Re: County of Sacramento Municipal Separate Storm Sewer System (MS4) Compliance
Audit Report

**MUNICIPAL SEPARATE STORM
SEWER SYSTEM (MS4)
COMPLIANCE INSPECTION**

**SACRAMENTO COUNTY,
CALIFORNIA**

INSPECTION REPORT

IMGP0980

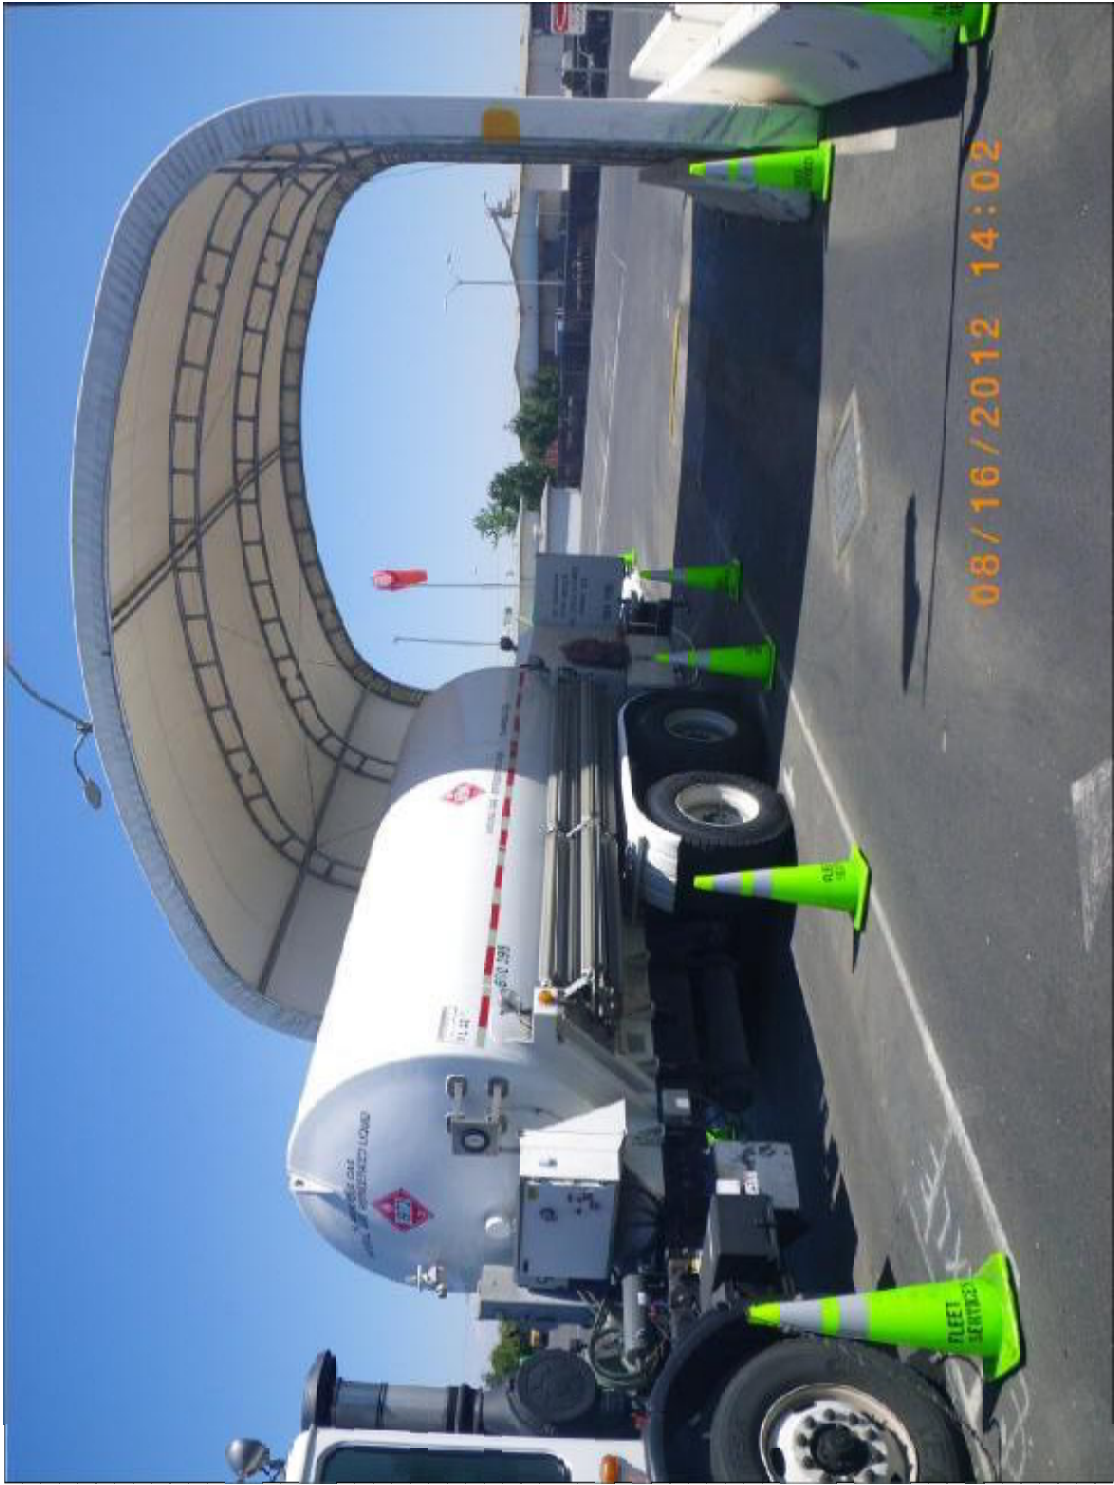
- The SWPPP describes catch basin filter inserts as a BMP used throughout the yard and the facility maps show which catch basins should have filters installed. During the site tour, EPA observed that some catch basins identified on the facility maps lacked such inserts (see photos IMG0980 and IMG0982).

- The DIs should be clearly labeled with "no dumping drains to river".
- The SWPPP should be revised to indicate which DIs flow to the storm vault for treatment prior to discharge.
- The County should ensure that all specified BMPs are fully implemented on a quarterly basis.
